INDIANA DEPARTMENT OF TRANSPORTATION

STANDARDS COMMITTEE MEETING AGENDA

RE: Agenda for the September 20, 2007 Standards Committee Meeting

STANDARD DRAWING NO. E 715-BKFL-01

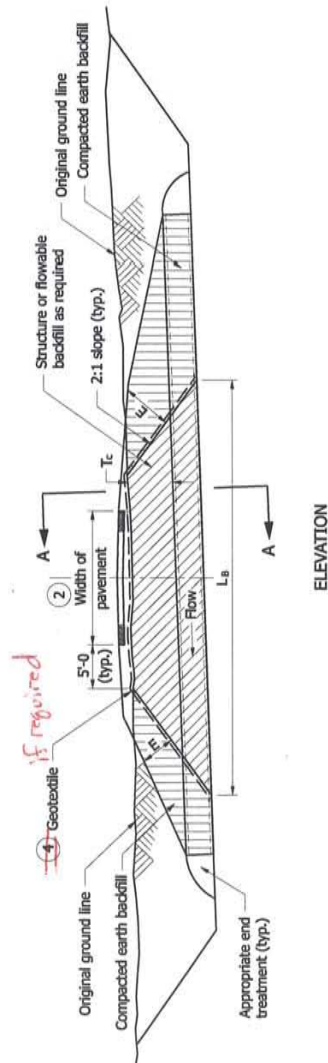
- NOTES:**
- Protective cover shall be constructed prior to running heavy equipment over installed pipes. The minimum covers are listed below:
 - 1.5' for $B_c \leq 18"$
 - 3' for $18" < B_c \leq 54"$
 - 4' for $B_c > 54"$
 - For backfill purposes, paved shoulders, curbs, and sidewalks are considered pavement. See Standard Drawing E 715-BKFL-10 for pavement limits when curbs, paved shoulders, or sidewalks are present.
 - Flowable or structure backfill shall be encased by compacted earth backfill. The minimum encasement shall be 2 ft. If necessary, the 2:1 slope between the flowable or structure backfill and the encasement shall be modified to maintain the minimum 2 ft encasement.
 - Geotextile required if coarse aggregate is used. Geotextile should extend 1 foot beyond each edge of the excavated trench or toe of slope.

STANDARD DRAWING NO. E 715-BKFL-02

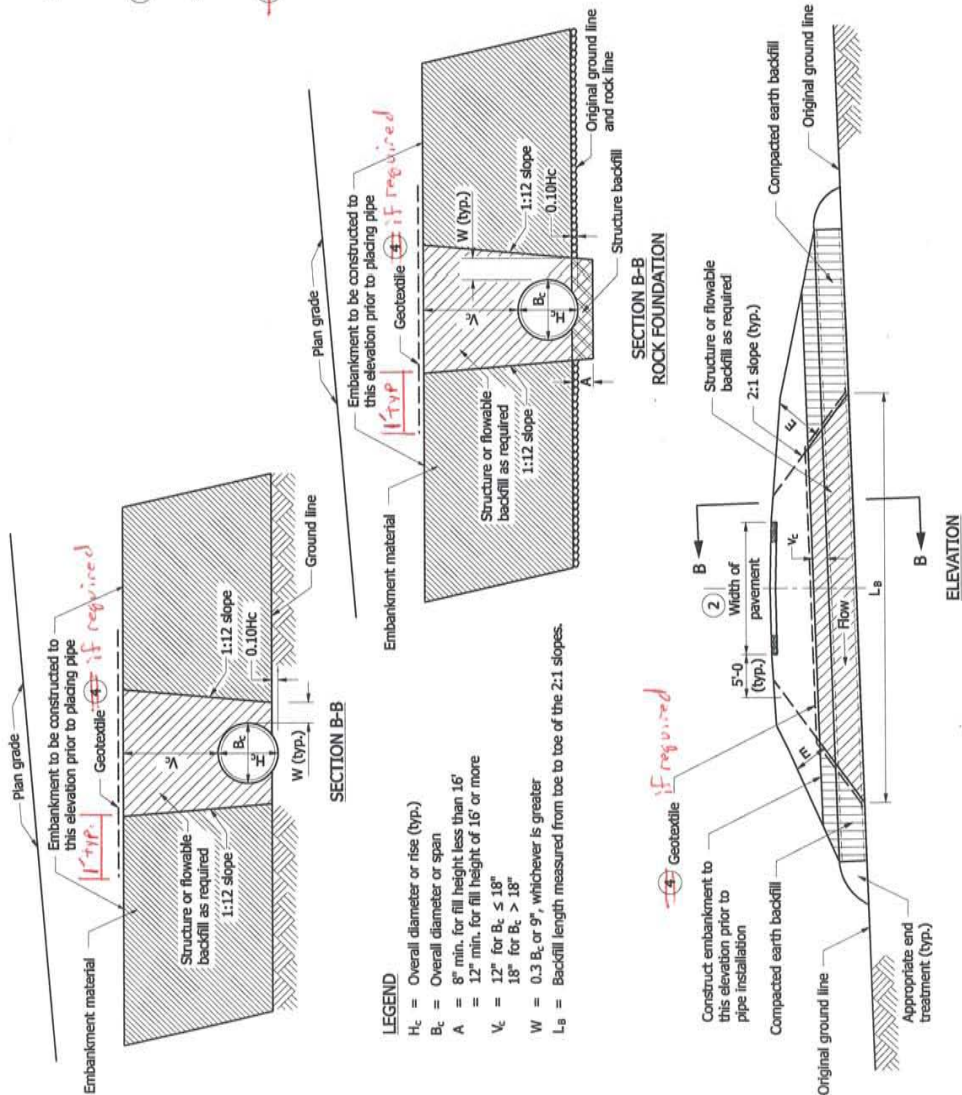
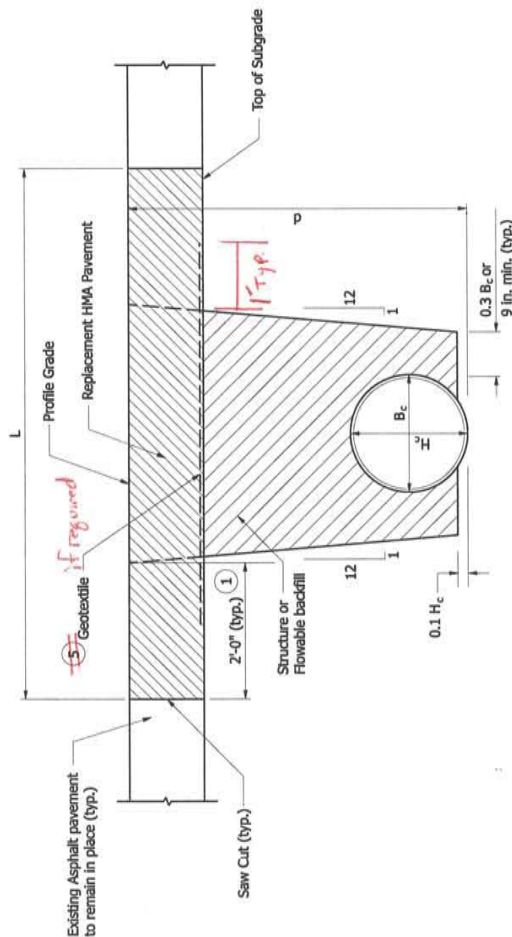
1. Protective cover shall be constructed prior to running heavy equipment over installed pipes. The minimum covers are listed below:
 - a.) 1.5' for $B_c \leq 18"$
 - b.) 3' for $18" < B_c \leq 54"$
 - c.) 4' for $B_c > 54"$
 2. For backfill purposes, paved shoulders, curbs, and sidewalks are considered pavement. See Standard Drawing E 715-BKFL-10 for pavement limits when curbs, paved shoulders, or sidewalks are present.
 3. Flowable or structure backfill shall be encased by compacted earth backfill. The minimum encasement shall be 2 ft. If necessary, the 2:1 slope between the flowable or structure backfill and the encasement shall be modified to maintain the minimum 2 ft encasement.
- ~~Geotextile required if coarse aggregate is used. Geotextile should extend 1-foot beyond each edge of the excavated trench or toe of slope.~~

STANDARD DRAWING NO. E 715-BKFL-03

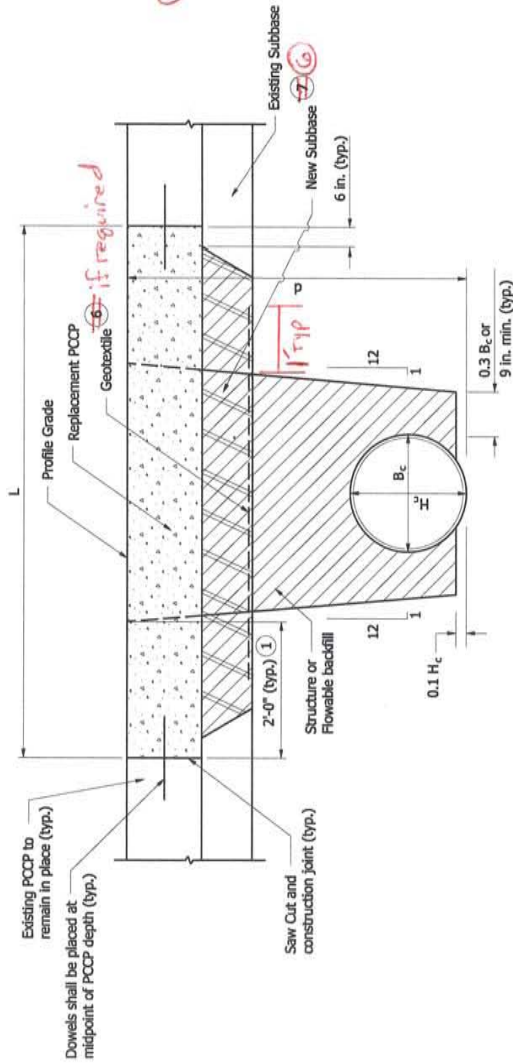
- 1 Existing subgrade over this distance shall remain in place.
- 2 The minimum pavement sections shall be as follows:
HMA: 165 #/yd HMA Surface, Type A,B,C or D on variable HMA Intermediate, Type A, B, C or D
- 3 If underdrains are present, they shall be perpetuated in accordance with the details shown on Standard Drawing E 718-UNDR-01.
- 4 See Standard Drawing E 715-BKFL-01 for pipe backfill trench elevation view.
- 5 ~~Geotextile required if coarse aggregate is used. Geotextile should extend 1-foot beyond each edge of the excavated trench.~~

STANDARD DRAWING NO. E 715-BKFL-04

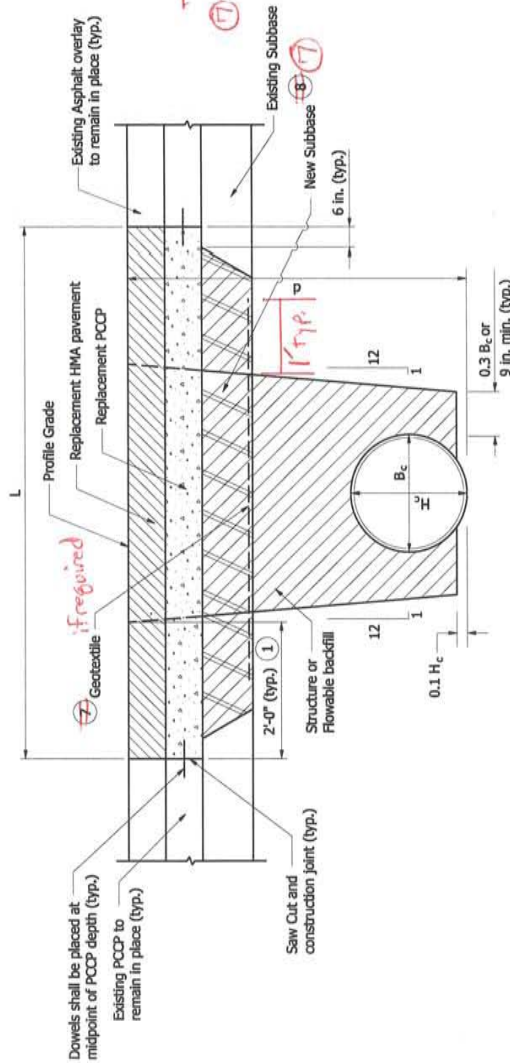
- ① Existing subgrade over this longitudinal distance shall remain in place.
- ② The thickness of the replacement PCCP shall match that of the existing concrete pavement.
- ③ See Standard Drawing E 506-COPP-01 for subbase, dowels, and construction joint details.
- ④ If underdrains are present, they shall be perpetuated in accordance with the details shown on Standard Drawing E 718-UNDR-01.
- ⑤ See Standard Drawing E 715-BKFL-01 for pipe backfill trench elevation view.
- ⑥ Geotextile required if coarse aggregate is used. Geotextile should extend 1 foot beyond each edge of the excavated trench.
- ⑦ New subbase type shall match the existing subbase type and thickness.

STANDARD DRAWING NO. E 715-BKFL-05

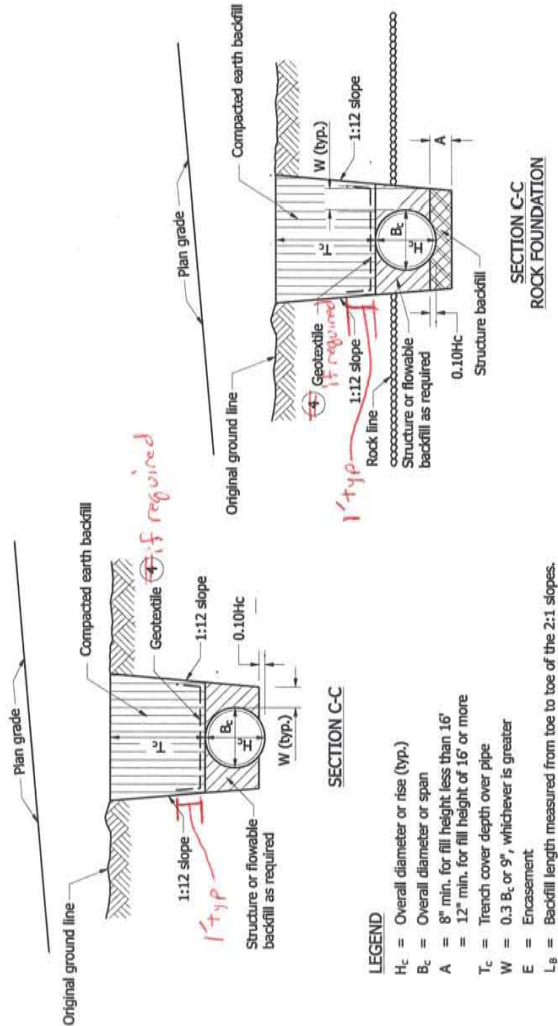
- 1 Existing subgrade over this distance shall remain in place.
- 2 The thickness of the replacement PCP shall match that of the existing concrete pavement.
- 3 The minimum pavement sections shall be as follows:
HMA: 165 #/yd HMA Surface, Type A,B,C or D on variable HMA Intermediate, Type A, B, C or D construction joint details.
- 4 See Standard Drawing E 506-CCPP-01 for subbase, dowels, and underdrains are present, they shall be perpetuated in accordance with the details shown on Standard Drawing E 718-UNDR-01.
- 5 See Standard Drawing E 715-BKFL-01 for pipe backfill trench elevation view.
- 6 ~~7~~ ~~Geotextile required if coarse aggregate is used. Geotextile should extend 1 foot beyond each edge of the excavated trench.~~
- 7 ~~8~~ ~~New subbase type shall match the existing subbase type and thickness.~~

STANDARD DRAWING NO. E 715-BKFL-07

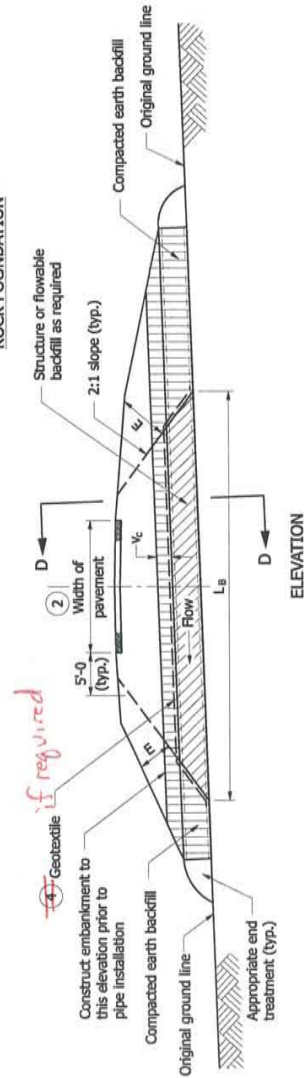
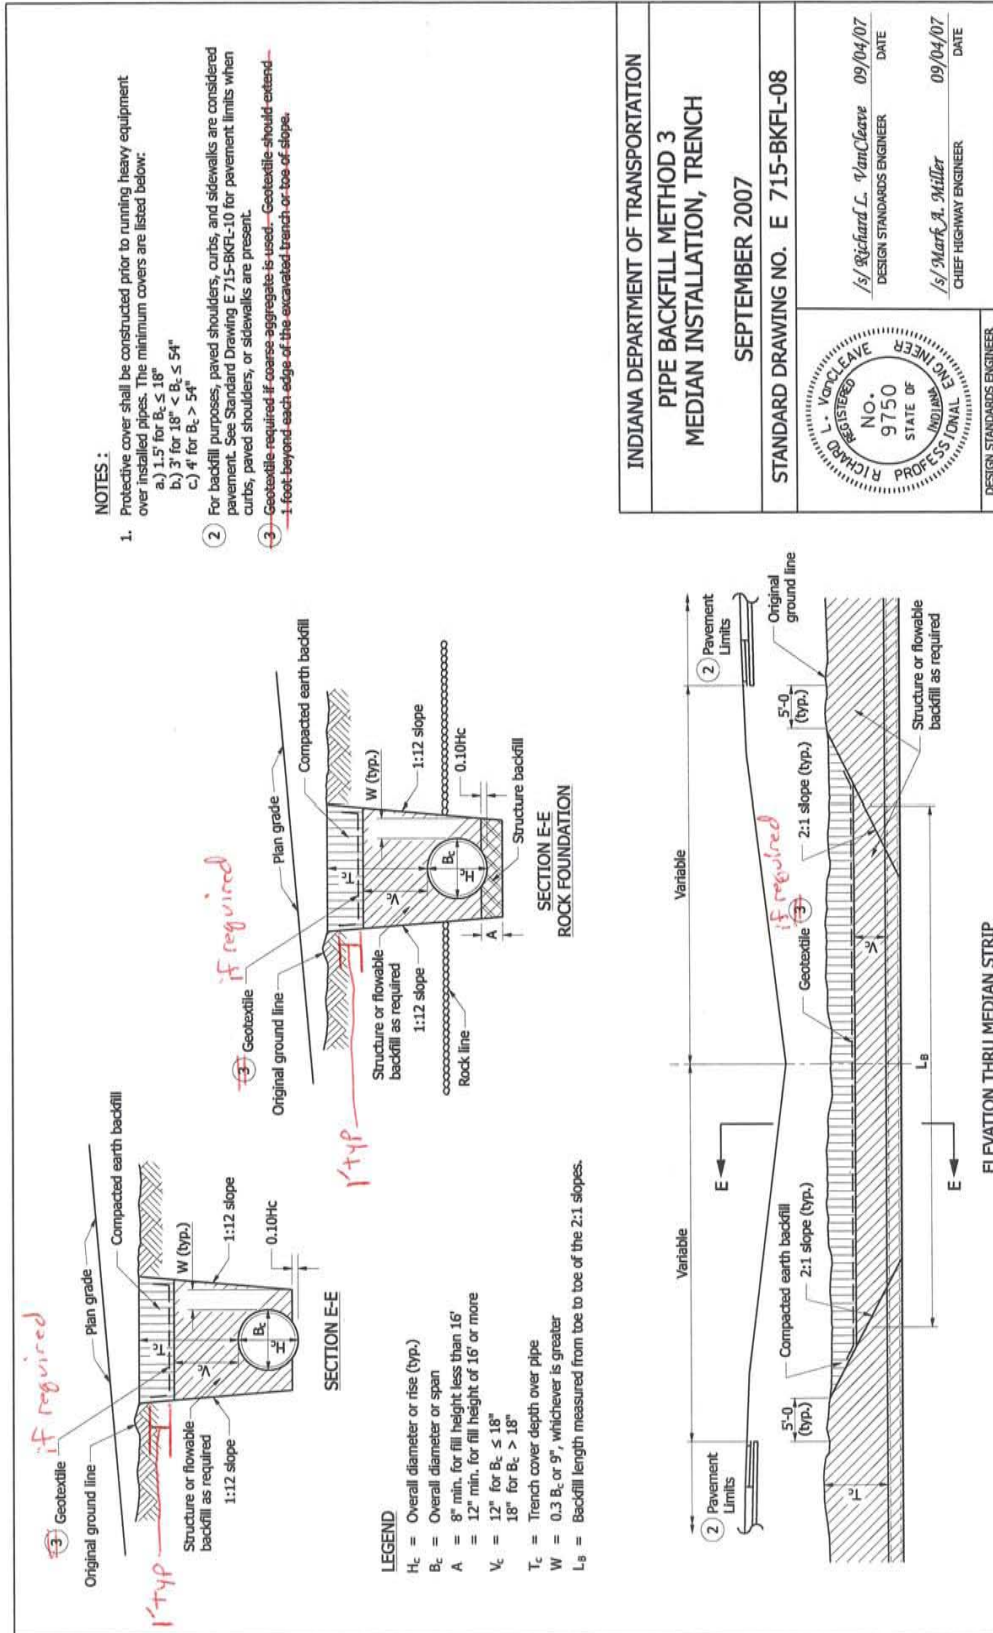
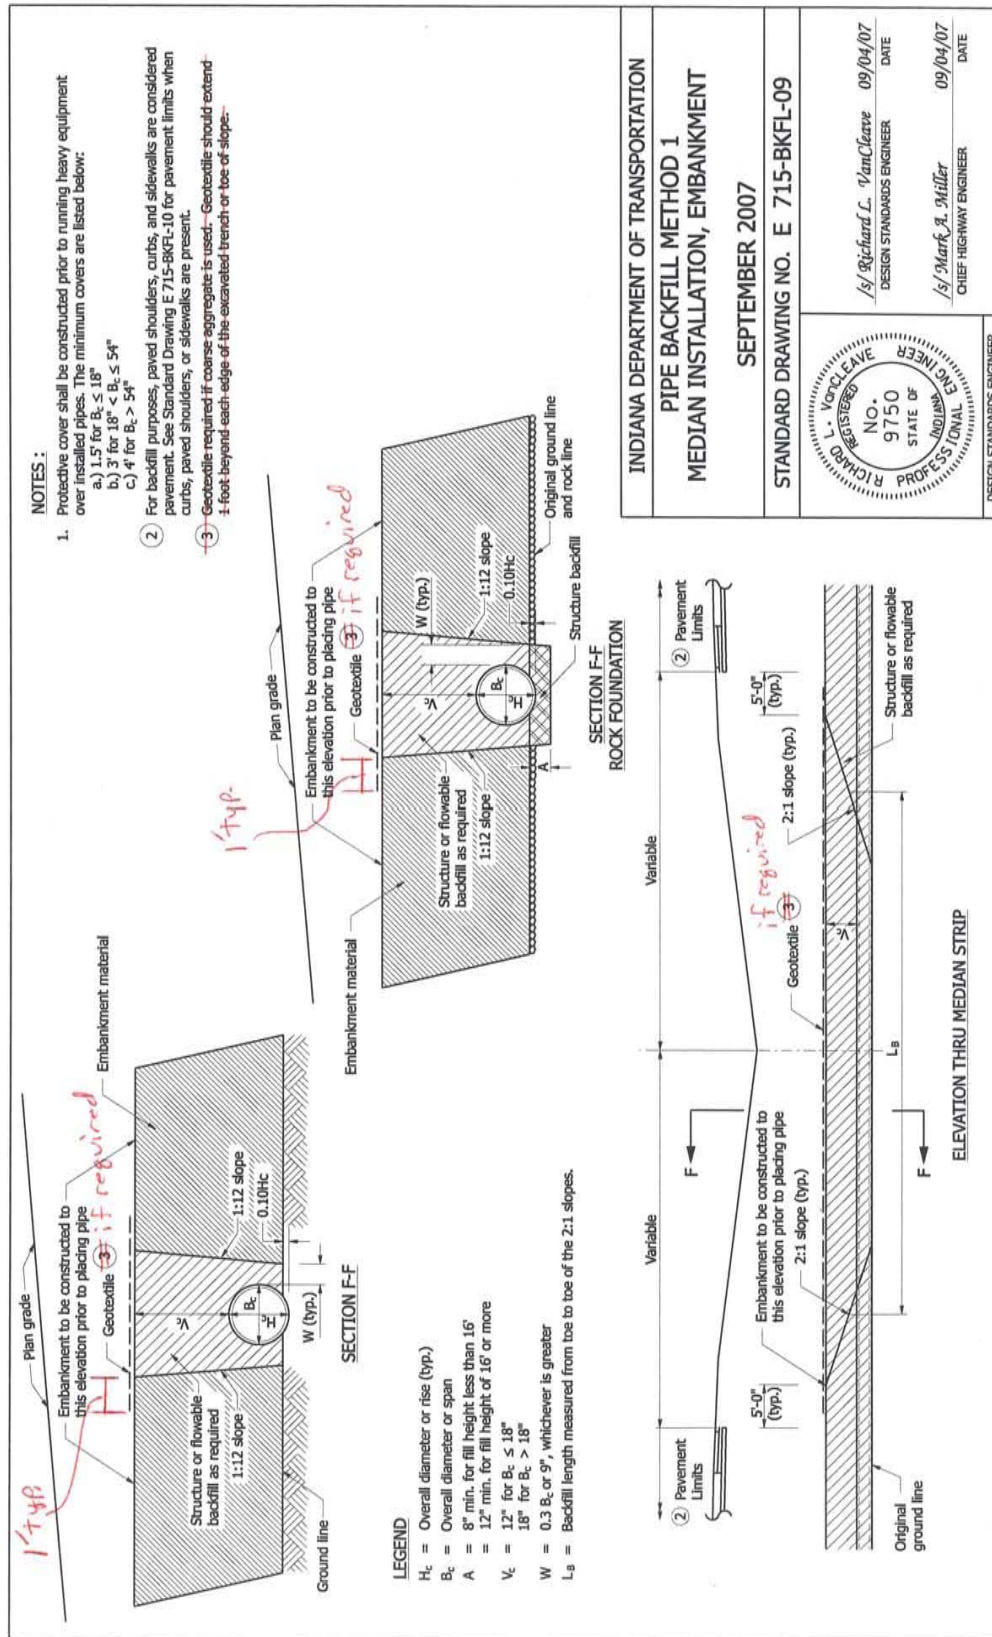
1. Protective cover shall be constructed prior to running heavy equipment over installed pipes. The minimum covers are listed below:
 - a.) 1.5' for $B_c \leq 18"$
 - b.) 3' for $18" < B_c \leq 54"$
 - c.) 4' for $B_c > 54"$
2. For backfill purposes, paved shoulders, curbs, and sidewalks are considered pavement. See Standard Drawing E 715-BKFL-10 for pavement limits when curbs, paved shoulders, or sidewalks are present.
3. Flowable or structure backfill shall be encased by compacted earth backfill. The minimum encasement shall be 2 ft. If necessary, the 2:1 slope between the flowable or structure backfill and the encasement shall be modified to maintain the minimum 2 ft encasement.
4. Geotextile required if coarse aggregate is used. Geotextile should extend 1 foot beyond each edge of the excavated trench or toe of slope.
